# **A1 in Northumberland: Morpeth to Ellingham**

**Scheme Number: TR010059**

## **6.8 Environmental Statement Appendix 10.4 - Drainage Strategy Report Part B (Tracked)**

**Environmental Statement Appendix 10.4 - Drainage  
Strategy Report Part B (Tracked)**

**Figure 4-6 - West Linkhall Road Proposal to use A1 Drainage Network**

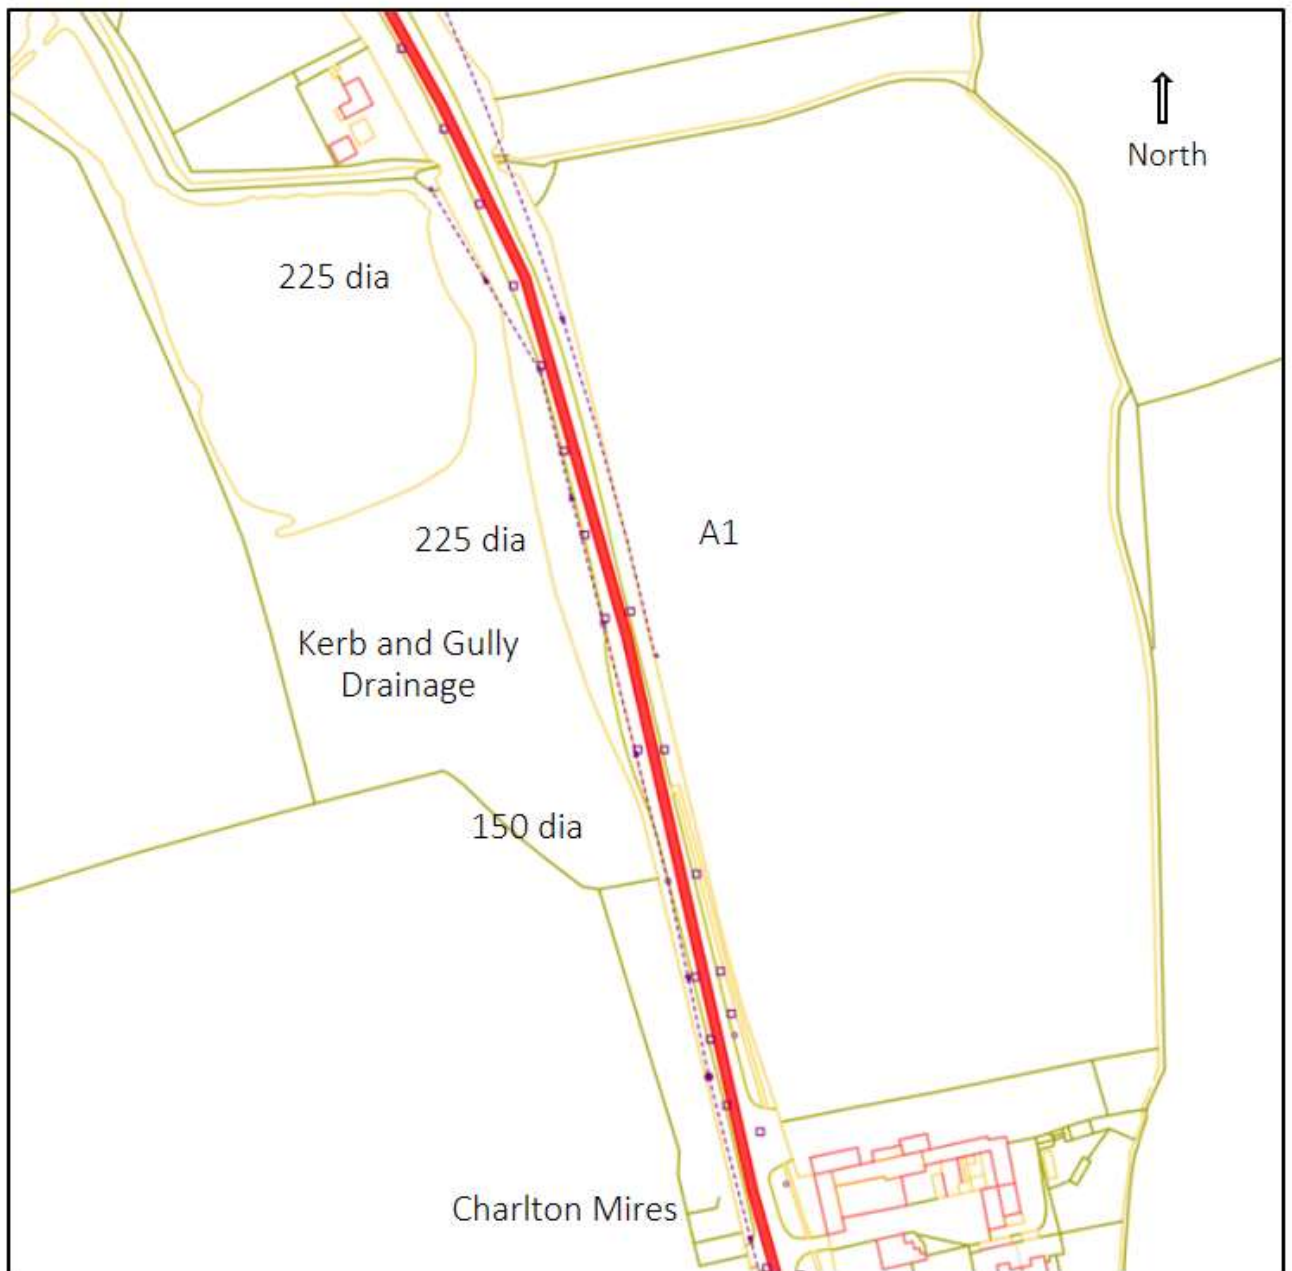
- e.** Two new local roads would be constructed in this area, they are the East Linkhall Road and the West Linkhall Road. These two roads would become the responsibility of the NCC once completed. The ~~it is proposed that the~~ East Linkhall Road ~~is to be a two lane road and this necessitates a positive drainage system, the proposed filter drain network is to connect to detention basin DB27a prior to controlled discharge to the tributary of the Kittycarter Burn~~would have over the edge drainage onto the field in which it would be constructed. It is proposed that the West Linkhall Road, which would be constructed generally on the line of the existing A1 northbound lane, would be drained using the existing A1 drainage system, refer to **Figure 4-6** below.

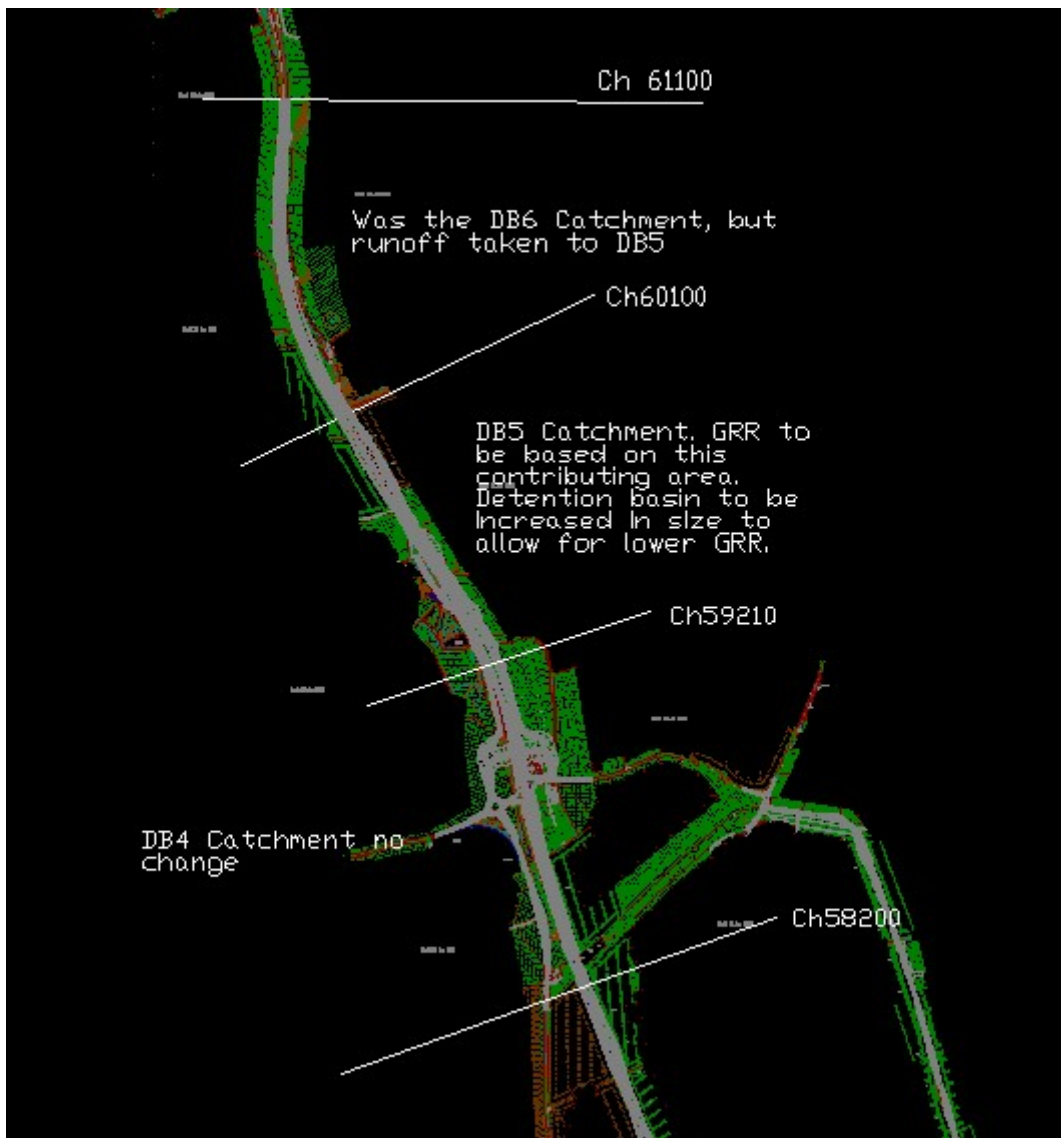
**6 Improvement works to the culvert and the general area are still requested and anticipated to be included as part of the works.**

**7 The watercourse assessment will need to look at the existing and proposed levels in the watercourse both upstream and downstream. A range of different events will need to be looked at up to and including the 1 in 100 year plus climate change event. The results of any watercourse assessment will need to conclude that the additional flows and volumes do not increase the risk of flooding at any location in any rainfall event.**

Chainage 58200 to 59120. Attenuation to be provided at detention basin DB4, part of the Kittycarter Burn catchment.
